## 40 Mahi Road: Ecologist s92 Comment

<b>To:</b>	Lance Hessel / Senior Planner / Civix Ltd.
<b>From:</b>	Karien Killian / Ecology Lead / Thomas Consultants
<b>Date:</b>	24/07/2025
<b>Subject:</b>	40 Mahi Road: Ecologist s92 Comment (updated)
<b>Attachments</b>	Revised Ecological Assessment and Maps

This memo provides further comments on ecology queries raised in the RFI letter dated 17 December 2024 from Austin Fox (Council's Senior Policy Planner), as well as further information requested by Council on 9 April 2025.

Figure 5: Concept Master Plan

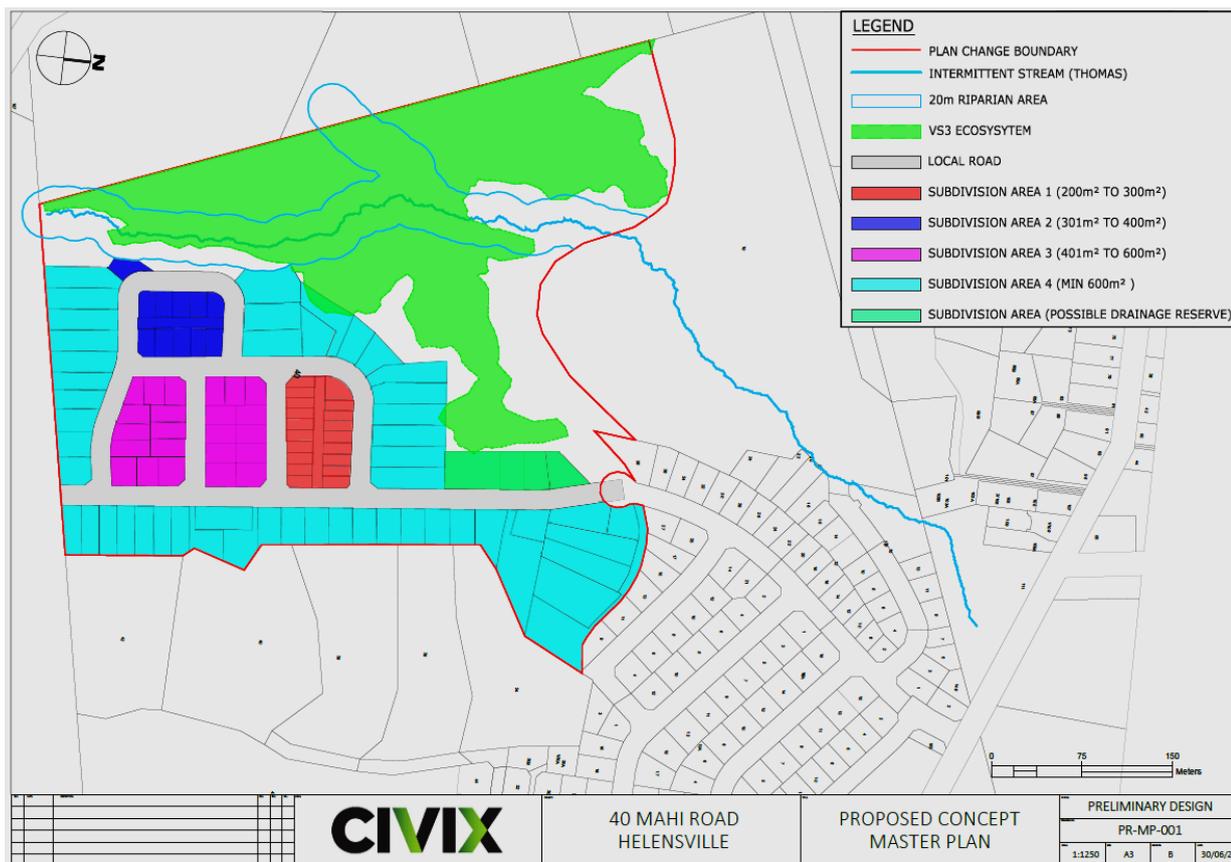
There is some ambiguity regarding the stream classifications. The Ecological Assessment report indicates that “Stream 3” and “Stream 6” are both ephemeral, and therefore would not be subject to riparian margin/yard restrictions. However, the Proposed Precinct Plan prepared by Civix indicates “potential riparian areas” along these streams where they extend into the proposed SHZ. Clarity should be provided regarding the status of these streams.

**Please provide an updated watercourse map for the site that clearly illustrates the appropriate classification for each stream.**

We note here that the referred Precinct Plan is no longer proposed, and the proposed updated concept Master Plan (indicative only to demonstrate possible development) is being submitted to show no riparian margins in relation to these ephemeral streams, and also to show the 20m riparian margin for Stream 1 as being wholly outside of the proposed Single House Zone and Mixed Housing Suburban Zone, and within the Countryside Living Zone. Refer to Figure 5 below.

Figure 6: Existing riparian vegetation along part of Stream 1, comprising of exotic scrub and grassland adjacent to kanuka/ manuka scrub.

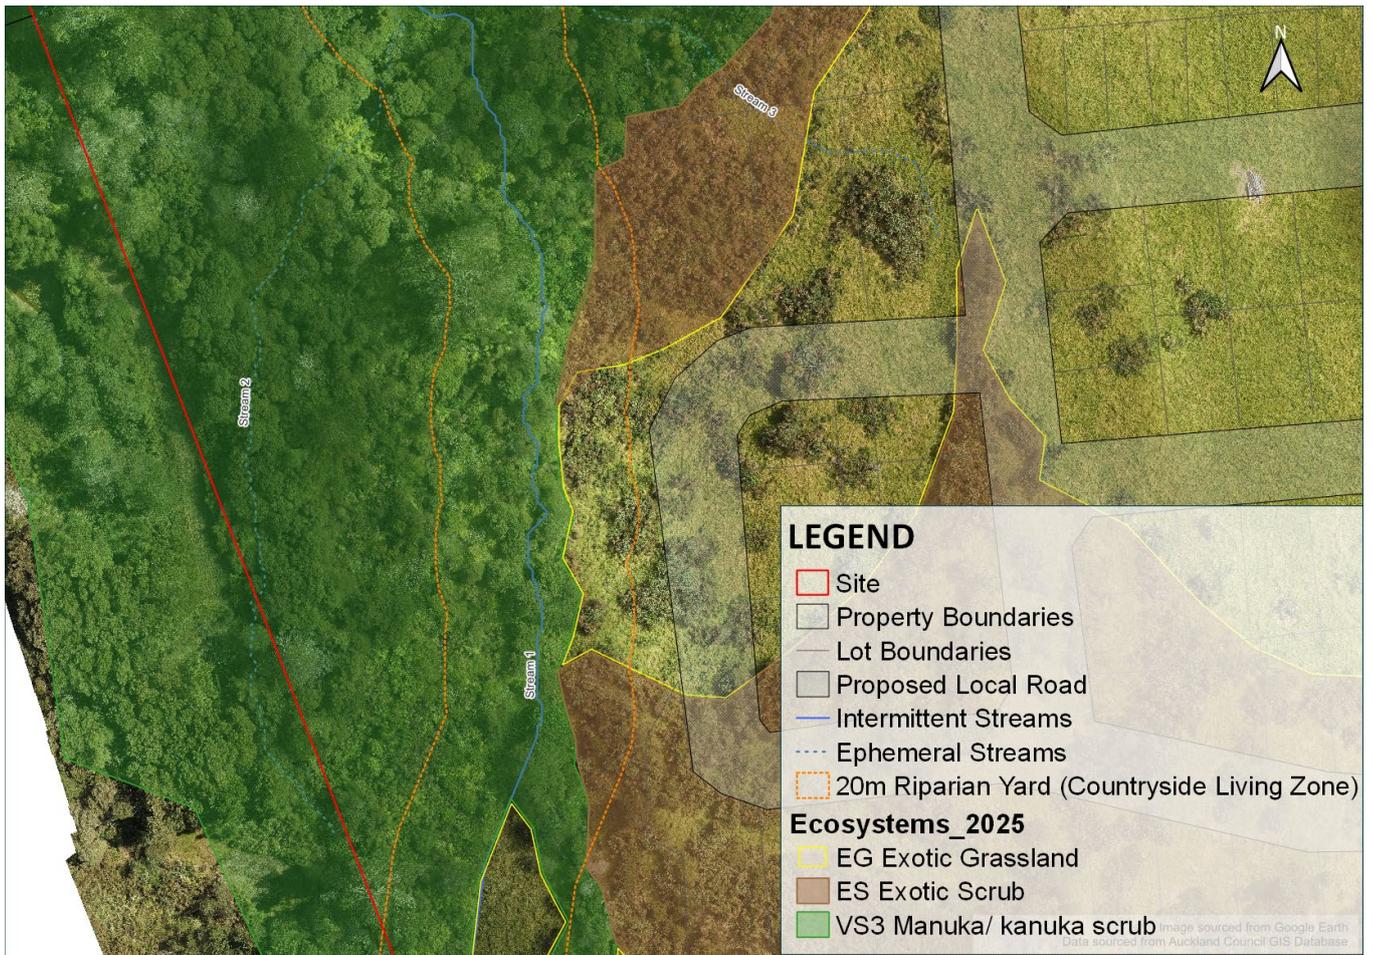
There is some ambiguity regarding the vegetation currently present in the riparian margins of the streams. For example, Photo 10 in the Thomas Consultants report shows Stream 1 flowing through open grassland, but the map appears to indicate that it flows through a mix of mānuka/kānuka scrub and gorse shrubland.

**Please provide a map that shows both the updated vegetation type extents and the updated watercourse classifications.**

As part of the proposal amendment to rely on zoning only and AUP provisions with no precinct applicable, the boundaries of the Countryside Living Zone and Single House Zone have been adjusted to ensure the 20m riparian margin under the Countryside Living Zone applies to Stream 1. This amendment is shown in Figure 6 provided below.

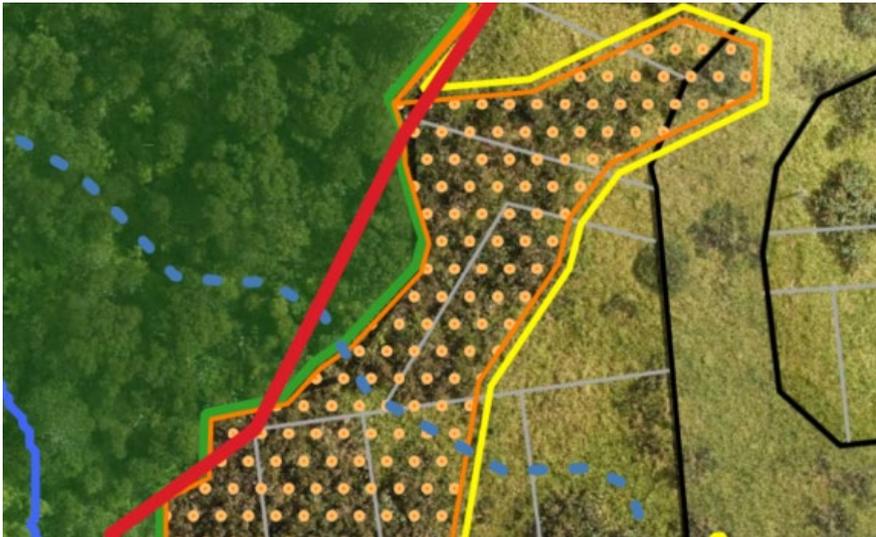
There is some ambiguity in the proposed precinct provisions regarding whether the removal of VS3 vegetation will be required. Policy I55X.3(4) requires the development to “ensure that subdivision and development of the SHZ and CLZ provides suitable access options to both zones and avoids development and subdivision requiring removal of ecological vegetation or works within watercourses in the ecological VS3 areas shown on the Precinct Plan.” However, Standard I55X.6.4.3(3) states that “The areas shown in the Precinct Plan as “VS3 – Ecological Area” must be avoided with respect to any vegetation clearance or earthworks for future subdivision and development in the SHZ or CLZ areas – *except where necessary to obtain reasonable access to any future CLZ subdivided lot*”. If policy I55X.3(4) is met, then the exception stated in Standard I55X.6.4.3(3) should not be required.

Please clarify if removal of VS3 (mānuka/kānuka scrub) vegetation is anticipated to allow for access to the CLZ or SHZ sites.

Civix has amended the Precinct provisions as provided in Cl23 responses to exclude the establishment of stormwater outfall structures to Policy I5XX.3(4) and reference is also included in Standard I55X.6.4.2(3).

Figure 3: Proposed zonings including amended Countryside Living Zone

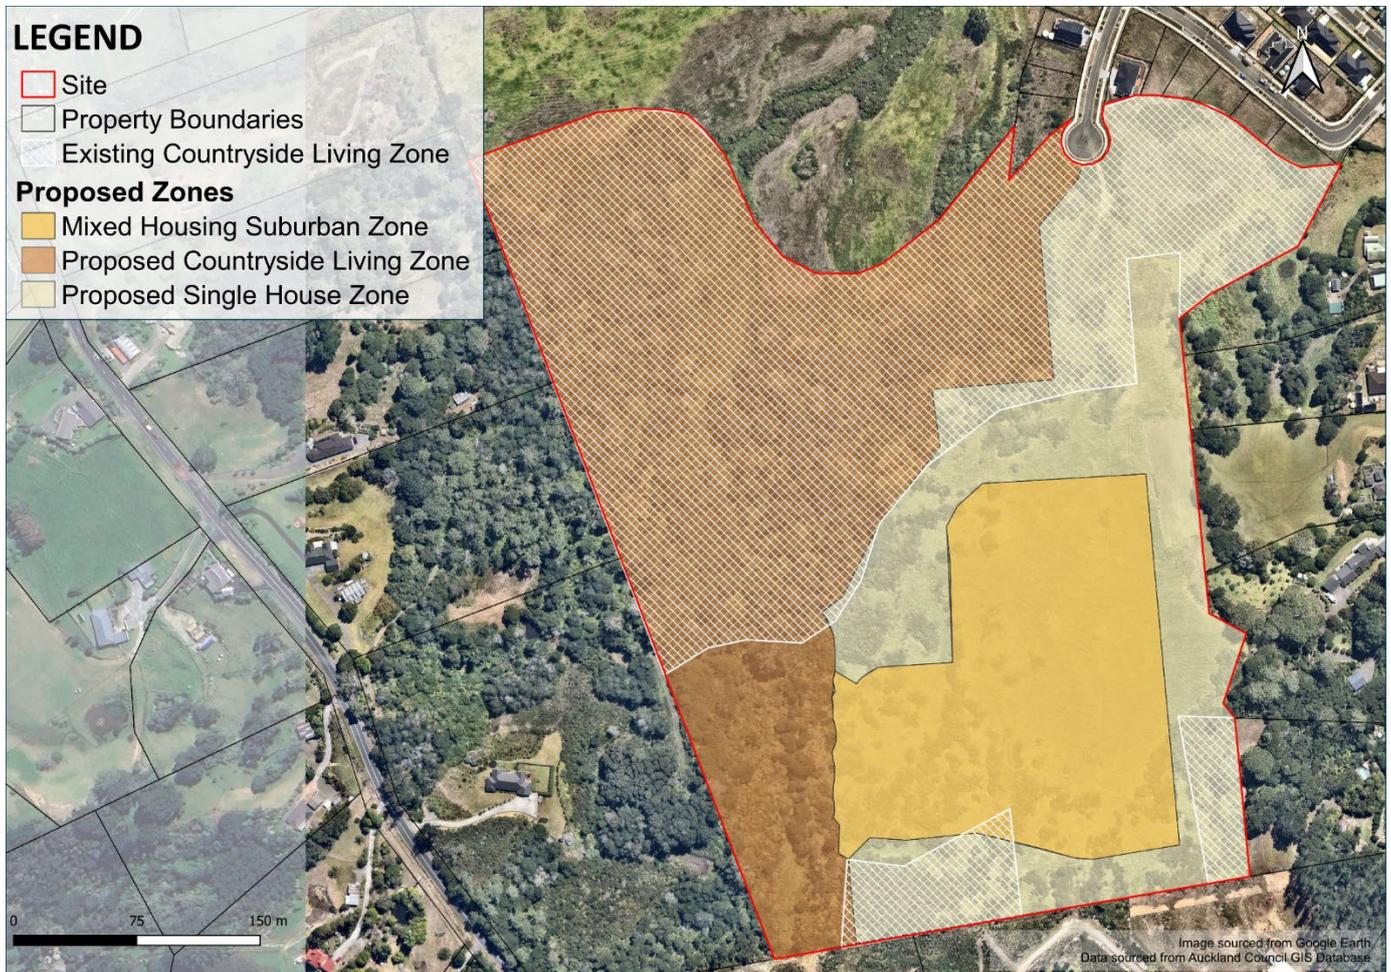
**Please justify the reduction of the riparian margin/yard from 20 metres to 10 metres adjacent to Stream 1.**

The argument put forward for the inclusion of a 10-metre-wide riparian margin adjacent to Stream 1 is not ecological in nature. Rather, it is based on the fact that other urban zoned areas have protected riparian widths of 10 metres.

In this case a 20-metre-wide margin would provide improved ecological outcomes and would make very little difference to the ability to develop the site (likely reduction in lot yield of up to five lots). The boundary of the SHZ should therefore be adjusted to be 20 metres from the top of the bank of Stream 1 so that the full 20 metre margin of this rural zoned stream is protected.

The proposed zoning plan has been amended to increase the Countryside Living Zone boundary to capture the 20m riparian margin, with no urban zoning located within this. The Concept Master Plan has also been amended to remove five lots adjacent to Stream 1 which encroached into the 20m riparian yard. All plans and reports have been revised to include a 20m riparian margin as enabled under the Countryside Living Zone provisions, instead of the 10m riparian margin previously referred to. The ecology report has been updated accordingly.

The proposed SHZ and Mixed Housing Suburban Zone have been set back 20m from Stream 1, as recommended. Five lots have been removed from the indicative Concept Master Plan where these were closest to the stream to demonstrate no urban development will occur in this margin. Further, Stream 1 and its 20m riparian margin are now located wholly within the Countryside Living Zone, so any proposed subdivision and development resource consent application related to this location will be required to address the protection and management of the Stream and margins as required under the Zone provisions.
